Cedar Street Pump Station Rehabilitation

ADDENDUM NO. 3

July 21, 2023

A1.1

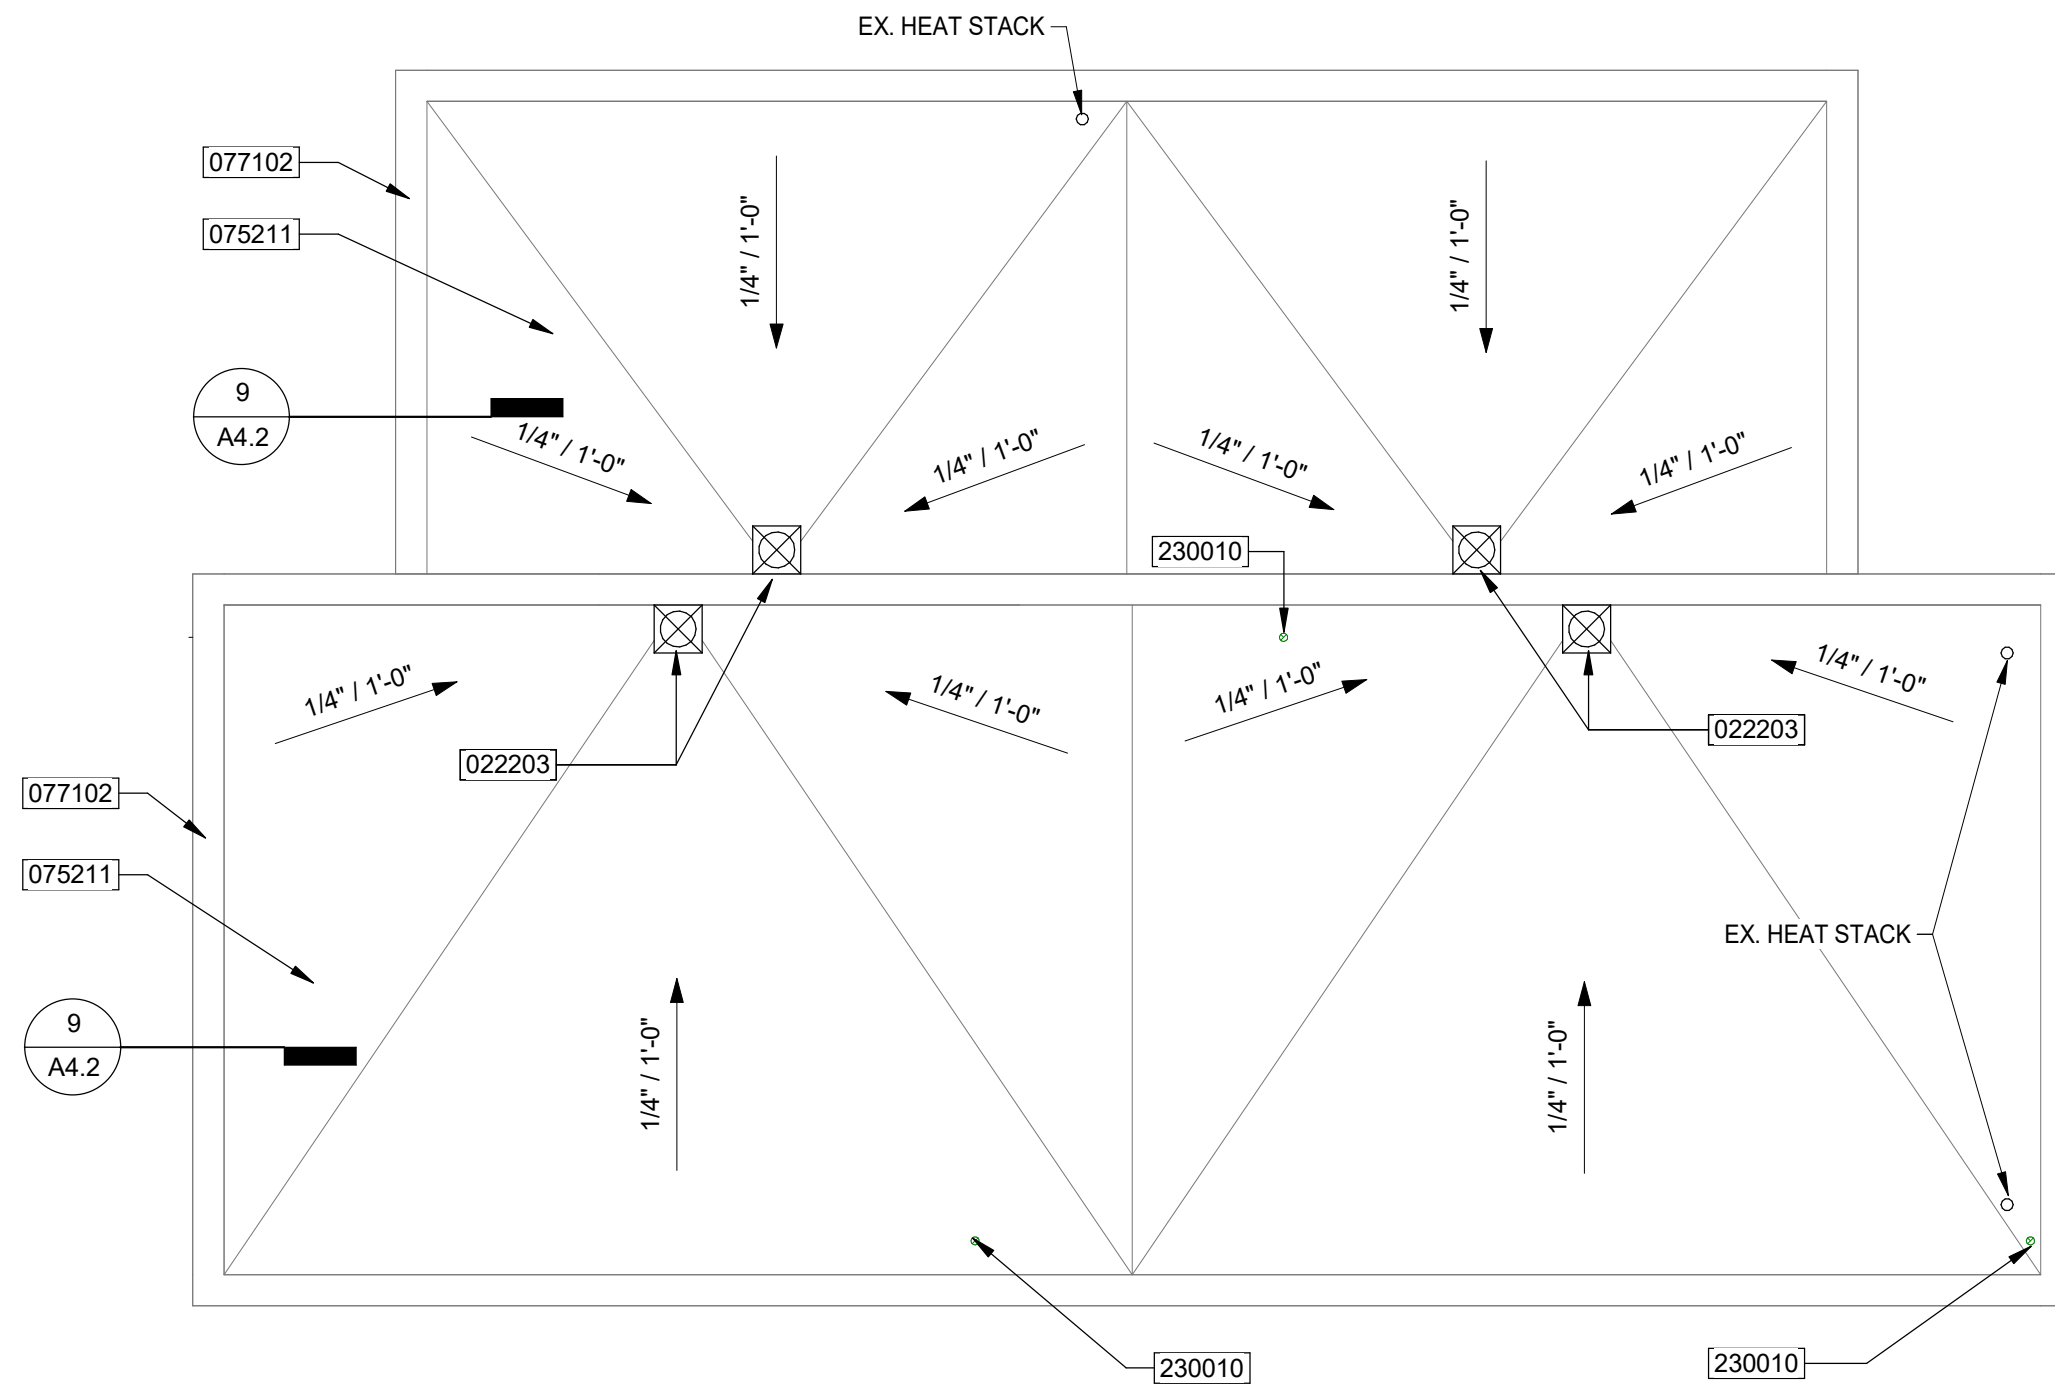
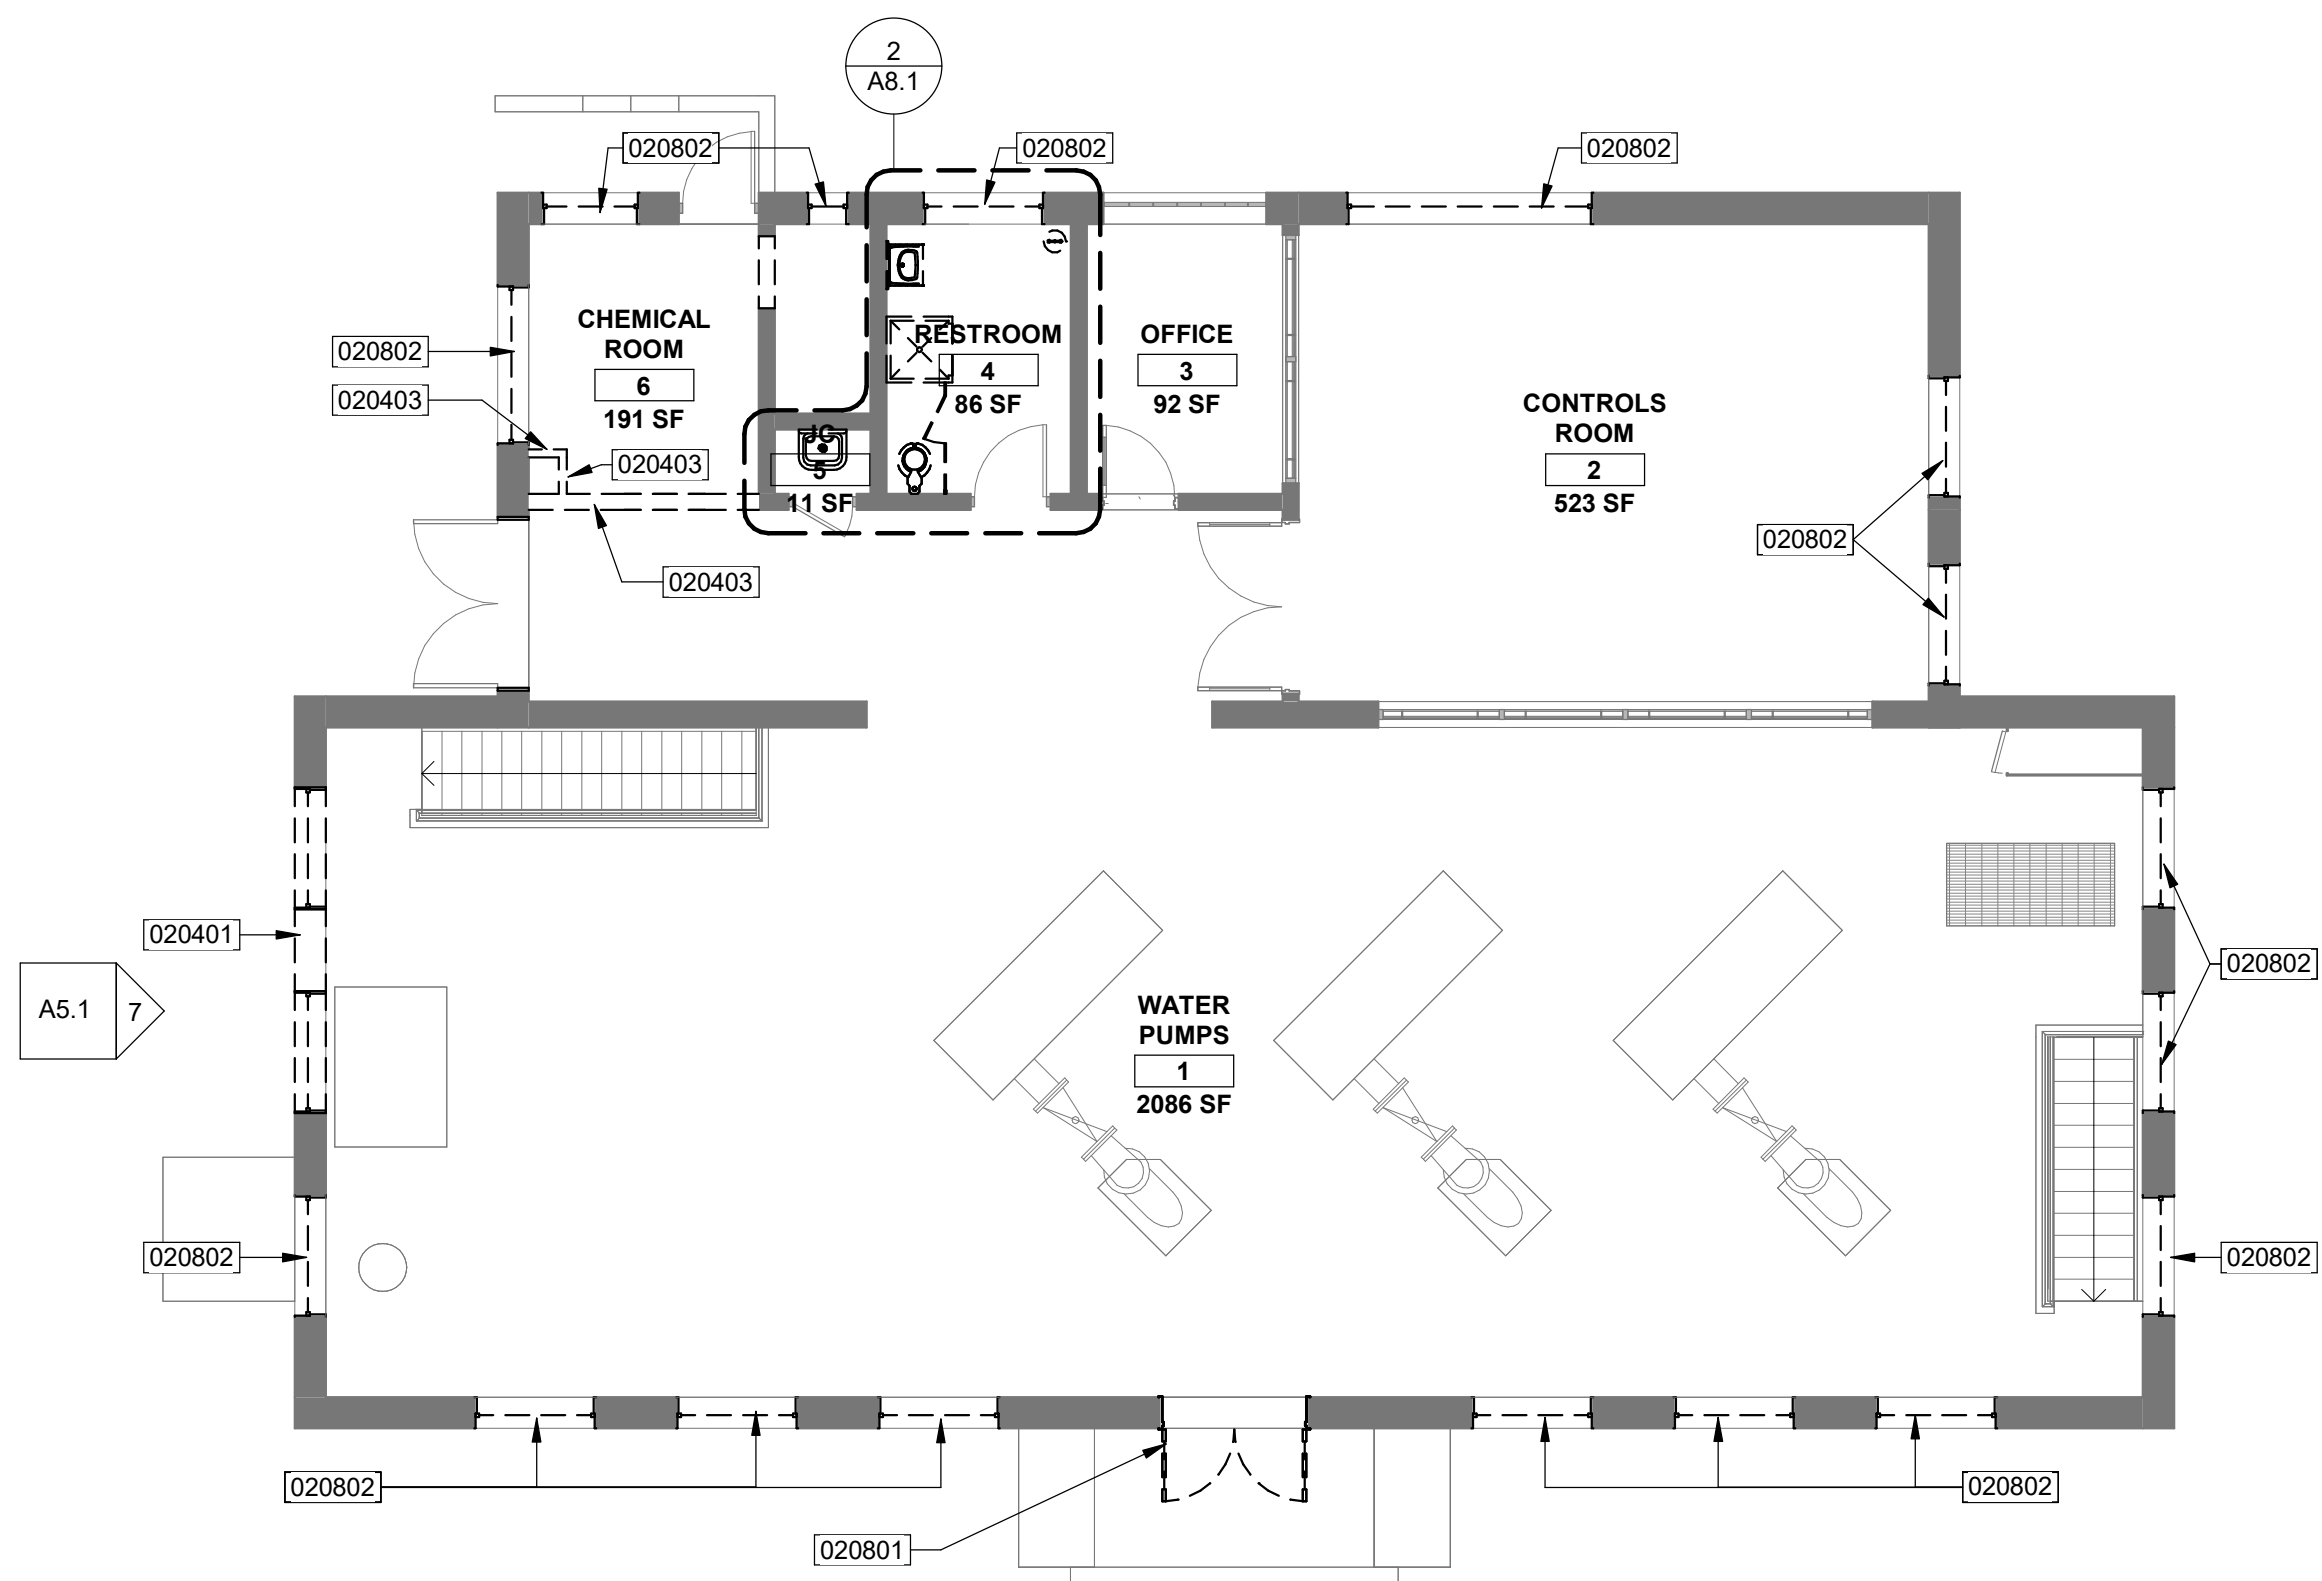
1. Keynotes 051209, 040111, 230014, 233102, and 23314 were revised to clarify work.
2. Water repellent keynote added to exterior elevations.
3. Steel lintel keynote added.
4. Tuck pointing was revised to cover the entire building instead of select areas. Total area is approximately 5,200 SF.
5. Roof repair detail for chimney removal added.
